Gulfstream G650ER

AIRCRAFT SERVICE CHANGE

NUMBER 069

FLIGHT CONTROLS (ATA 27)
PRIMARY FLIGHT CONTROL ACTUATION
SYSTEM (PFCAS) REMOTE ELECTRONICS UNIT
(REU) SOFTWARE UPDATE

**FIGURE 1. REU PHYSICAL SOFTWARE LABELS SHOWING REU 35 INSTALLED**

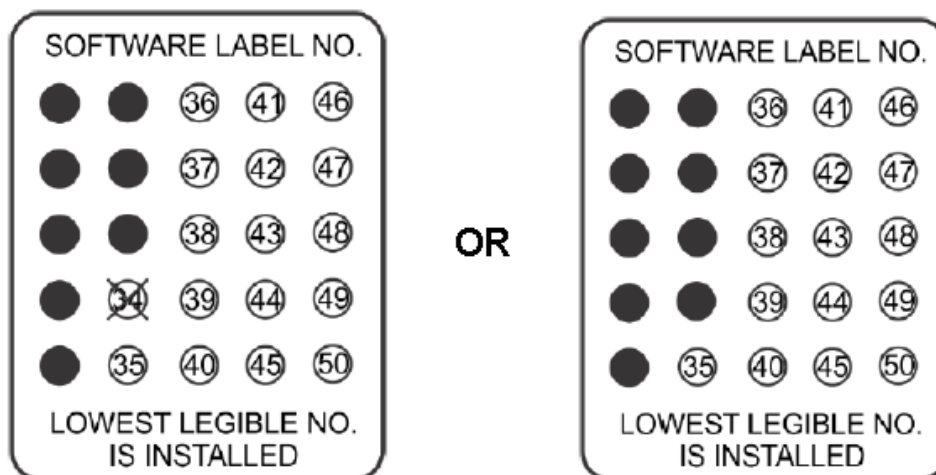
NOTE:	The potential exists for REUs of both Label 34 and Label 35 to be installed on the same aircraft. Any REU already containing Label 35 software will not require software update. Some REUs may have been updated or replaced on an attrition basis due to individual component removals. If an REU already contains the physical marking for software Label 35 (see examples of physical label possibilities in Figure 1), then software update in accordance with this ASC is not applicable and may be omitted for that particular unit. However, if there is any question as to which particular software is loaded to a unit, then the unit should be updated via this ASC. The intent of this ASC is for every REU on the aircraft to contain the REU Label 35 software upon completion of the ASC.
-------	--

1. Review pages 1 – 3 of this ASC for any applicable actions or requirements. Ensure aircraft meets all configuration requirements prior to beginning modification.
2. Remove electrical power. Refer to AMM, Chapter 20.
3. Gain access to the REUs in accordance with AMM procedures listed in Table 1.
4. Identify REUs requiring update to Label 35.
